WOLF CREEK

WM 97-0006

Reference: 1) Letter WM 95-0129, dated August 30, 1995, from
N. S. Carns, WCNOG, to USNRC
2) Letter dated November 25, 1996, from USNRC,
to N. S. Carns, WCNOG
Subject: Docket No. 50-482: Response to Request for Additional
Information, Second 10-Year Interval Inservice
Inspection Program Plan and Associated Requests for
Relief

RESPONSE TO REQUEST FOR ADDITIONAL INFORMATION

Figure 1
RV-101-121 Scan Limitations

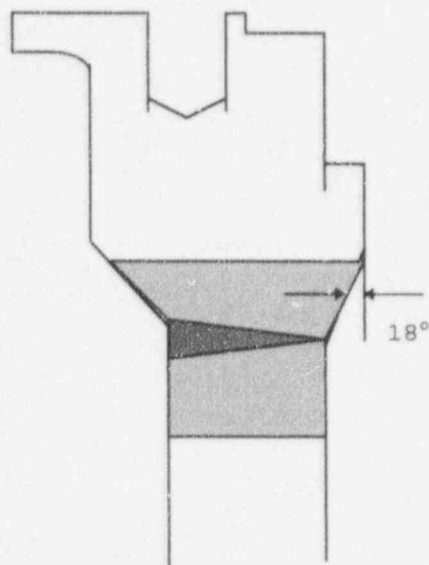
Due to the vessel flange taper above the subject weld (inner and outer diameter configuration), 100% examination coverage can not be achieved. Figure 1 represents a drawing (not to scale) of the Flange to Upper Reactor Vessel Shell Weld and the applicable beam directions/angles are listed with the appropriate examination coverage.

The manual examination portion from the flange surface has not been performed for the Second 10-Year Inspection Interval but greater than 90% coverage was attained for the first interval. The amount of coverage for weld metal (WM) interrogation is shown as a separate value to identify the amount of coverage in the volume where a crack would have a higher probability of presence. The limitations described above were included in a request for relief for the first ten year interval at WCGS, and relief was subsequently granted.

None; the Code required volumetric examination will be completed to the maximum extent practical.

FIGURE 1
CH-103-101 Scan Limitation
Cooling Ring Limitation

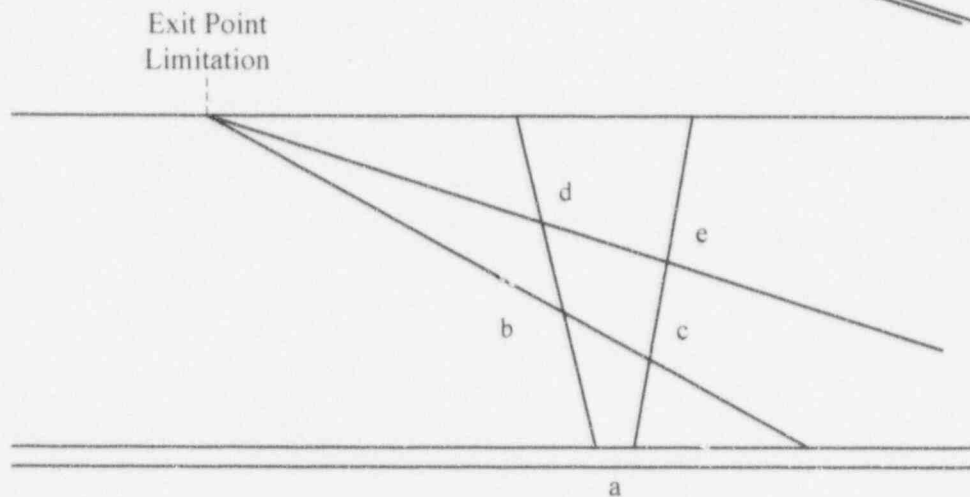
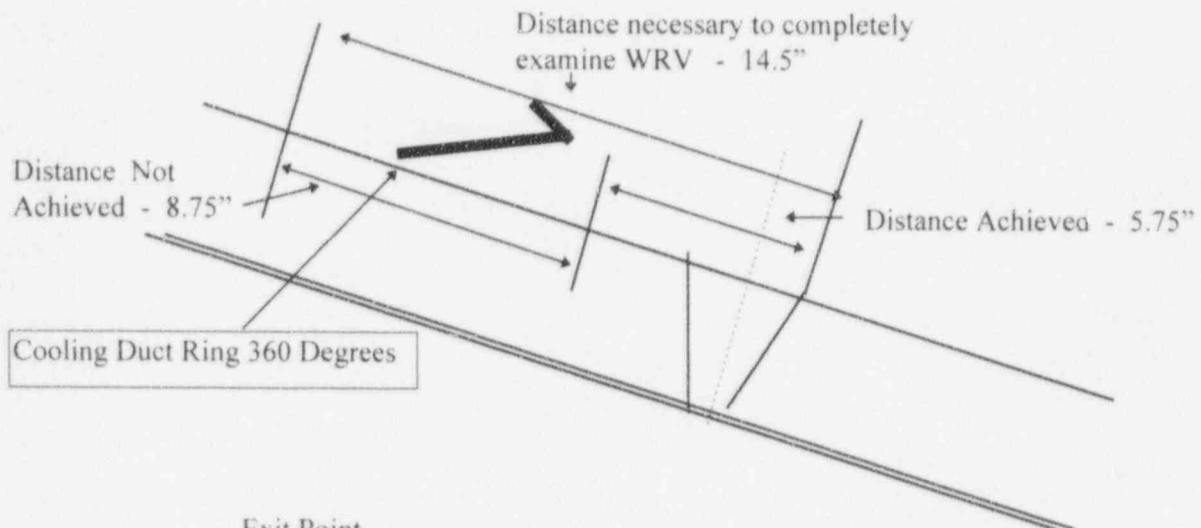
Due to the cooling duct ring limiting the required scan path and three lifting lugs obstructing portions of the weld examination volume, the Code required examination cannot be 100% completed. The weld metal can be 100% inspected in one direction by the 45 degree and the 60 degree angle beam, but is limited in the other direction due to the cooling ring. This results in 16.8% of the weld metal not being examined by the 45 degree angle beam and 47.3% not being examined by the 60 degree angle beam. Obstruction by three lifting lugs results in 5.3% of the required examination volume not being examined.

abc represents portion of weld not examined
in two directions by $45^\circ = 16.8\%$

ade represents portion of weld not examined
in two directions by $60^\circ = 47.3\%$

None; the Code required volumetric examination will be completed to the maximum extent practical.

FIGURE 1
EBB01D-SEAM-1-W Limitations

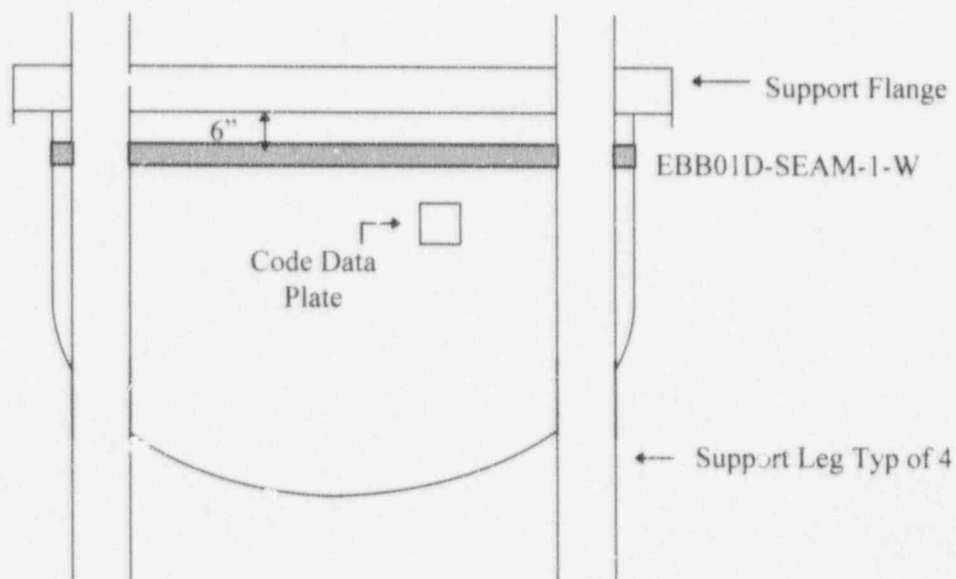
Due to the four (4) support legs obstructing 22.4% of the volumetric examination with, at least, an additional 9.3% and 33.4% of the volumetric examination obstructed by the component design, while using the 45° and 60° angle beam, respectively, the Code required examination cannot be completed.

None; the Code required volumetric examination will be completed to the maximum extent practical.

FIGURE 1
TBB03-10A-W Limitations

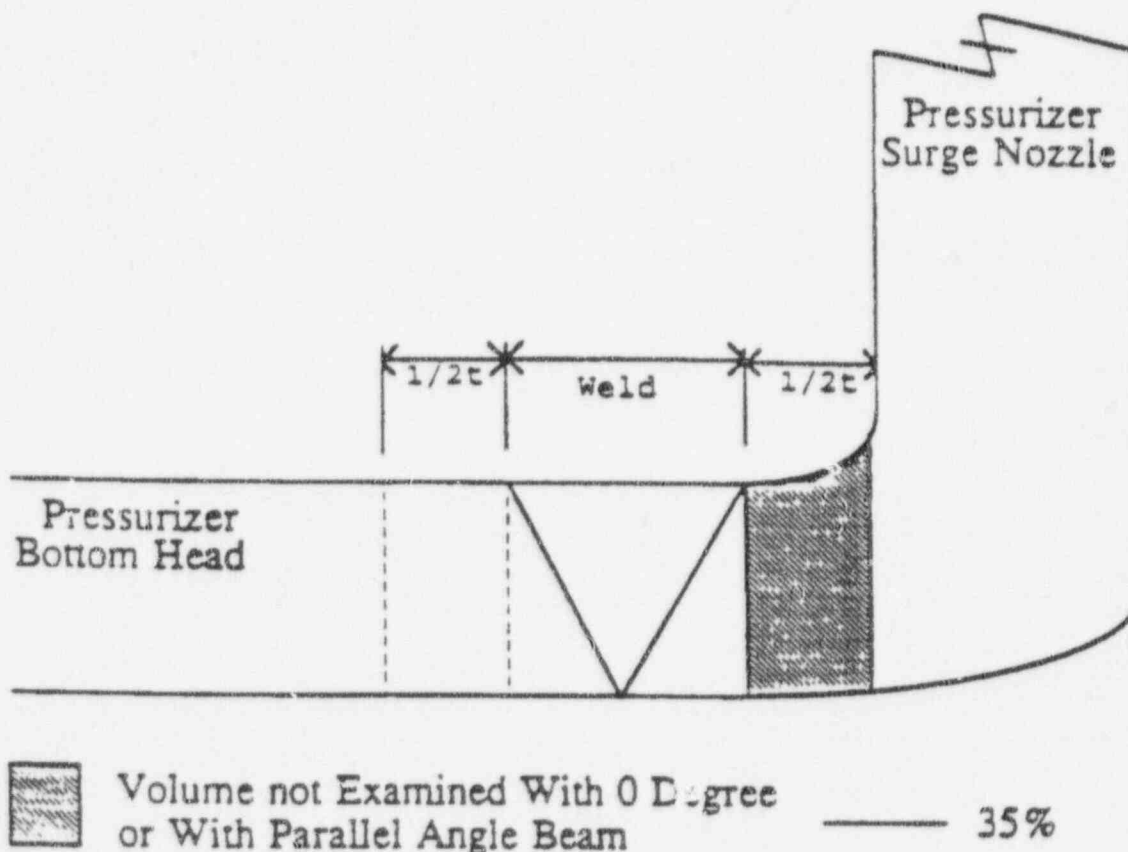
The Pressurizer shell configuration and the proximity of the heaters results in 35% of the weld required volume not being examined with the 0 degree or with the parallel angle beam scan (See Figure 1). In addition, the weld metal can only be examined in the one direction and the adjacent base metal is not fully examined in one direction with two beam angles (92% complete with 60 degree angle beam and 88.4% complete with 45 degree angle beam, see Figure 2).

None; the Code required volumetric examination will be completed to the maximum extent practical.

FIGURE 2
TBB03-10A-W Limitations

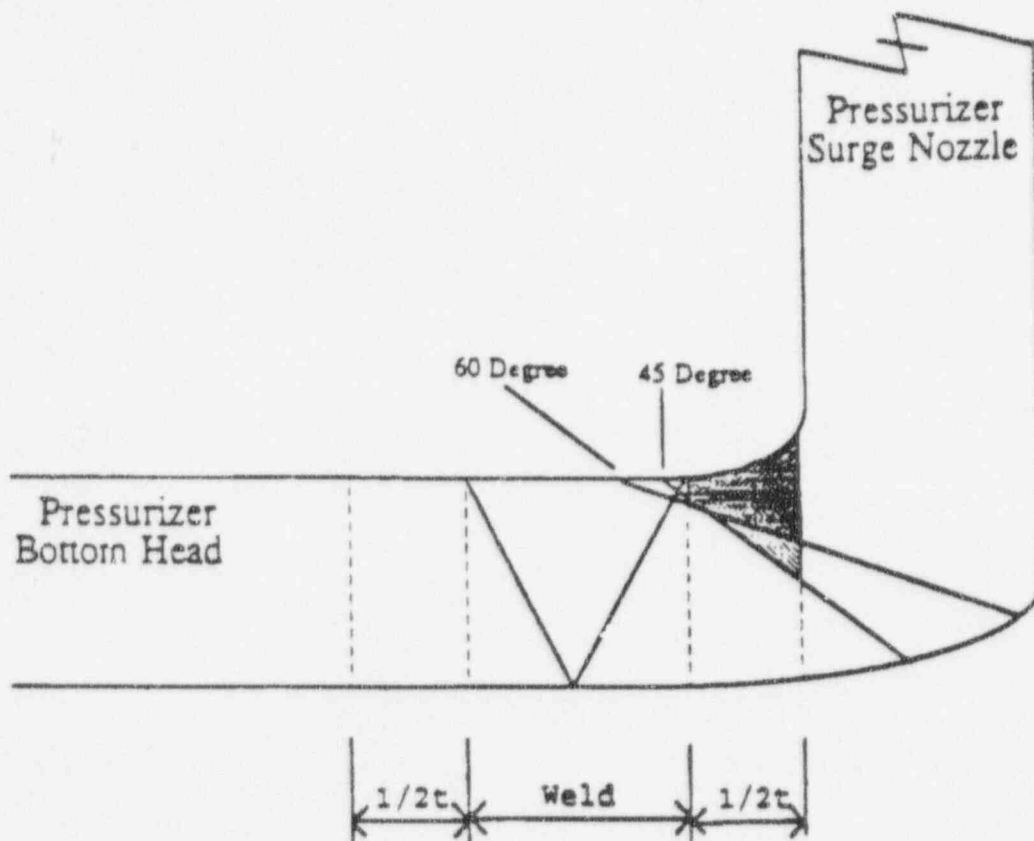
Volume not Examined by 45 Degree Angle Beam — 3.6%

Volume not Examined by 45 or 60 Degree Angle Beam — 8%

FIGURE 1
TBB03-10A-IR Limitations

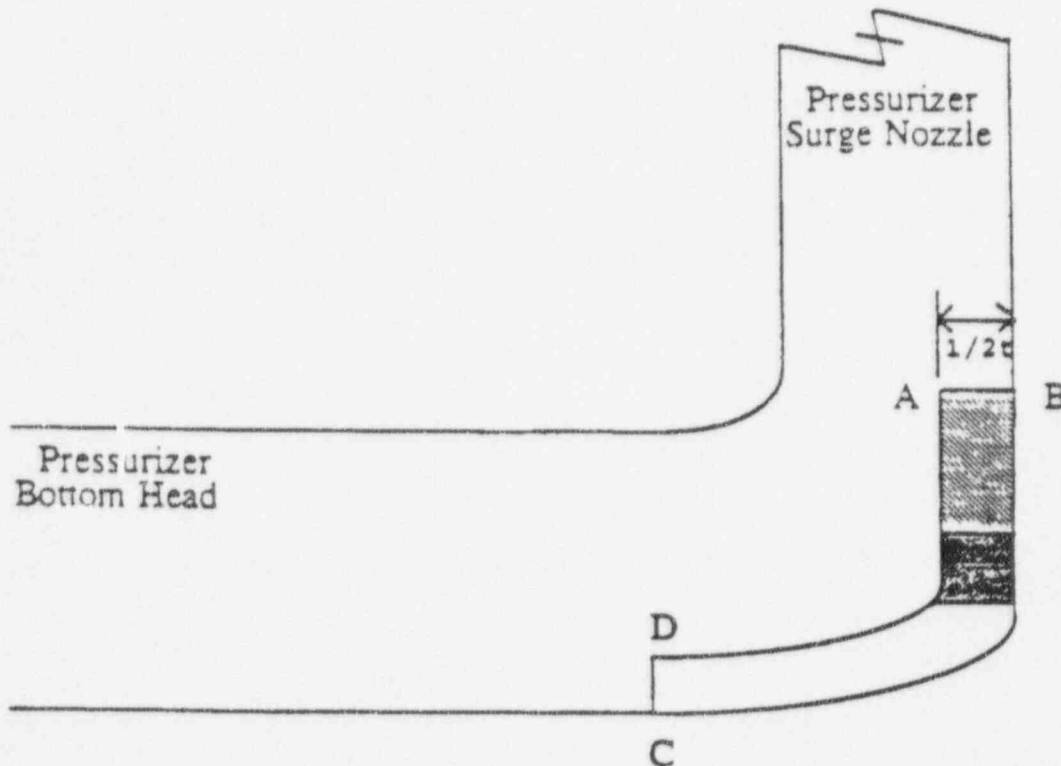
Relief is requested from the Code requirement to volumetrically examine 100% of the subject welds due to the interferences by the Pressurizer heater penetrations and nozzle configuration. As a result, 70% of the required weld volume cannot be inspected, (See Figure 1).

-  Volume not Examined, 360 Degrees — 41%
-  Volume Examined, 360 Degrees — 21%
-  Volume Examined, 86 Degrees Only — 38%
(resulting from 18" gap in heater penetrations)

• • 70% of Total Exam Volume is not Examined

None; the Code required volumetric examination will be completed to the maximum extent practical.

FIGURE 1

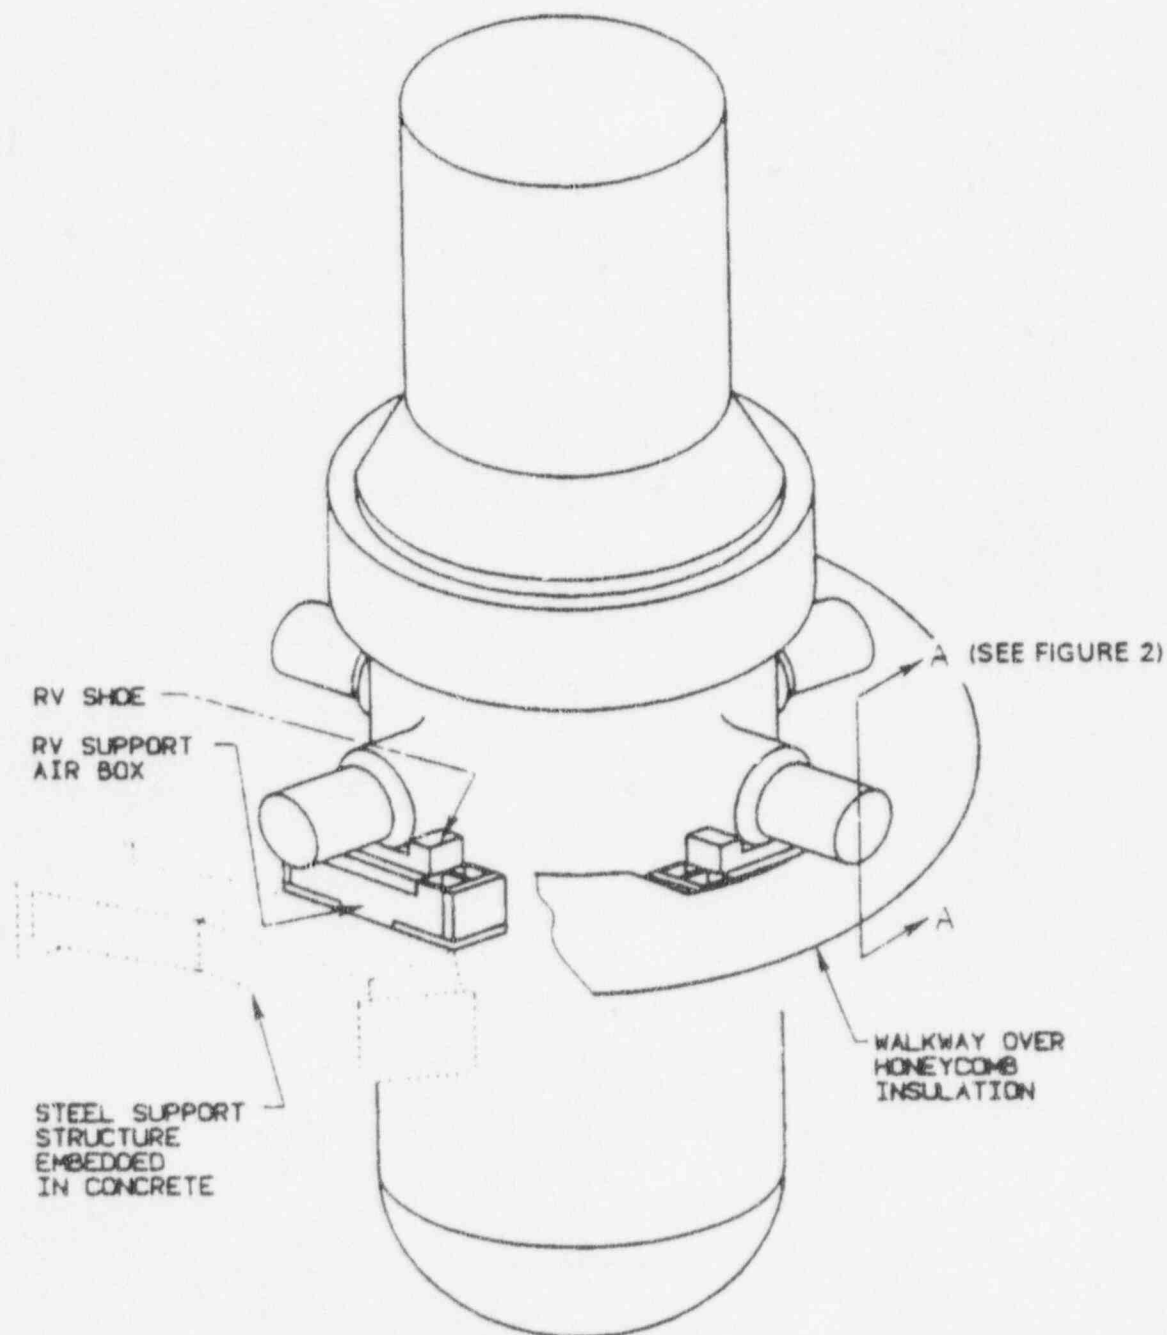
The WCGS Reactor Vessel is supported by two cold leg nozzles and two hot leg nozzles. There is a support assembly at each of these nozzles that consists of a nozzle weld build up, shoe plate, air cooled box, and steel support structure embedded in the primary shield wall. Figure 1 depicts these support assemblies. As shown in the figure, only the nozzle weld build up and shoe plate are completely accessible for a visual VT-3 examination. The majority of the air cooled box and the entire steel support structure are located beneath a steel walk plate and only the top of the air cooled box is directly accessible. An additional 20 to 30 percent of the air cooled box and a very small percentage of the steel support structure would be made accessible if the steel walk plate and insulation were removed.

A visual examination VT-3, with the walk plate and insulation installed, shall be performed to the extent practical on the accessible NF portions of the Reactor Vessel support assemblies to satisfy the requirements of Code Case N-491, Table -2500-1, Item No. F1.40. If conditions are discovered during this limited visual examination VT-3 that do not meet the acceptance standards of N-491, -3400, the walk plate or insulation will, if necessary, be removed to meet the evaluation requirements of N-491, -3112.2 or -3112.3.

FIGURE 2

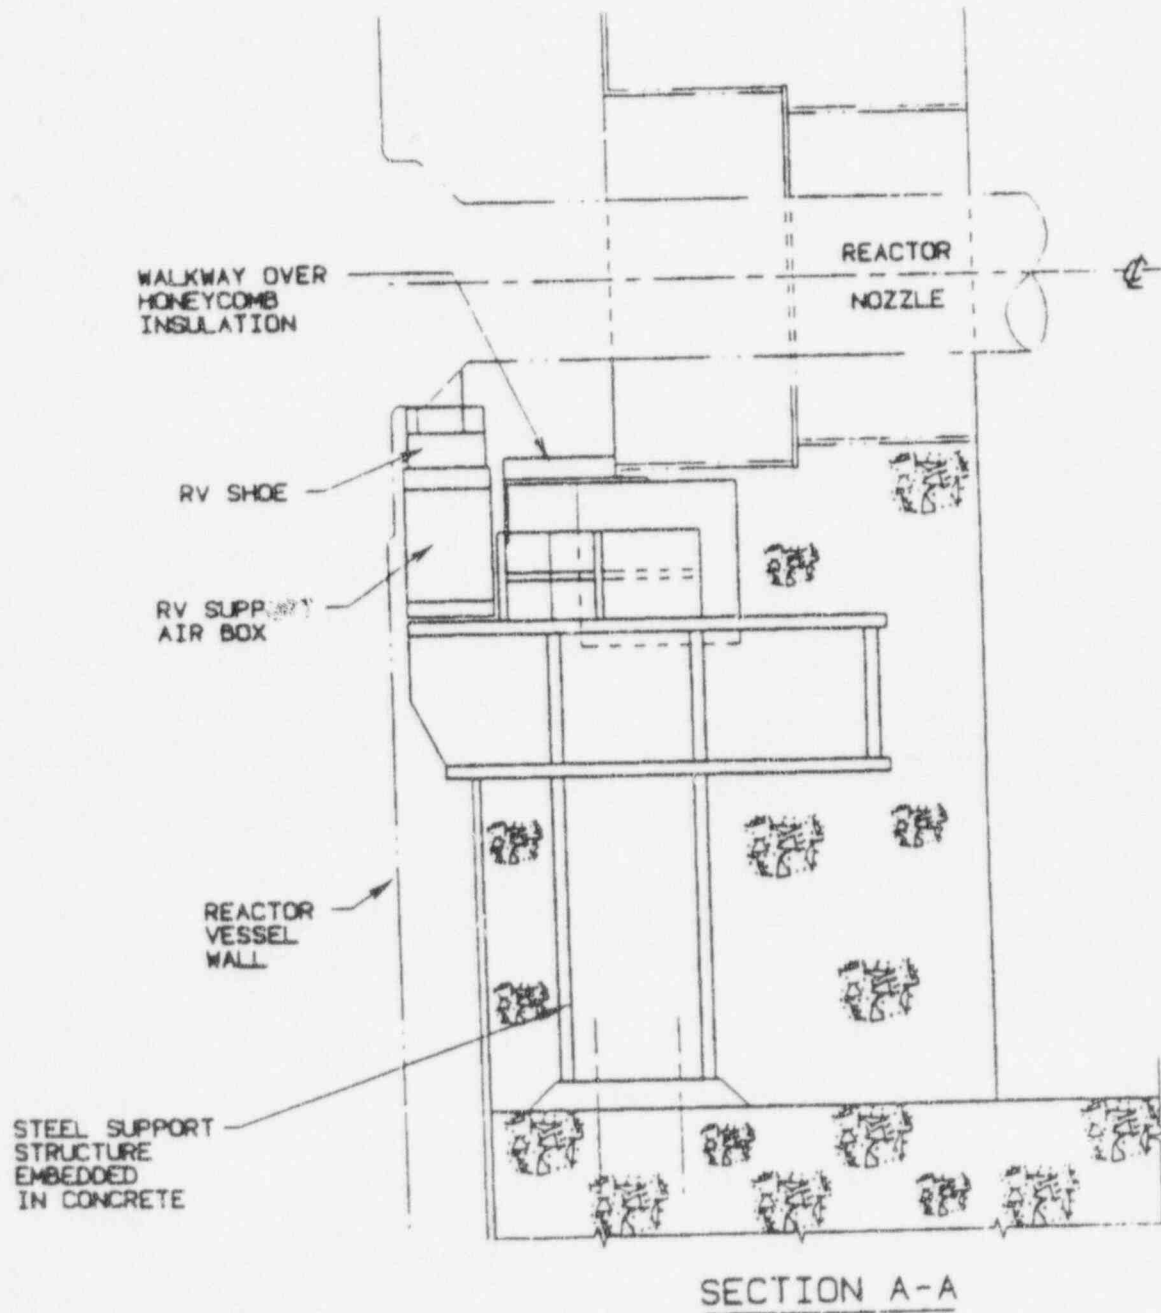
The Reactor Vessel supports are located in a confined space below the refueling pool permanent seal ring. The area can only be accessed through four seal ring hatches. In addition to difficult access, the radiation in the area is between 1.5 to 2.0 man-rem per hour. It is estimated that the removal and re-installation of the walk plate and insulation in this confined space, combined with the visual VT-3 examination, would result in an exposure of approximately 36 man-rem. Removal of the walk plate and insulation under these conditions to increase the examination of the air cooled box by approximately 20 to 30 percent and a very small percentage of the steel support structure is considered impractical without a commensurate increase in quality or safety. Based on this, relief is requested from the visual VT-3 examination of the air cooled box and steel support structure that is obstructed by the walk plate and insulation. The limitations described above were included in a request for relief for the first ten year interval at WCGS, and relief was subsequently granted.
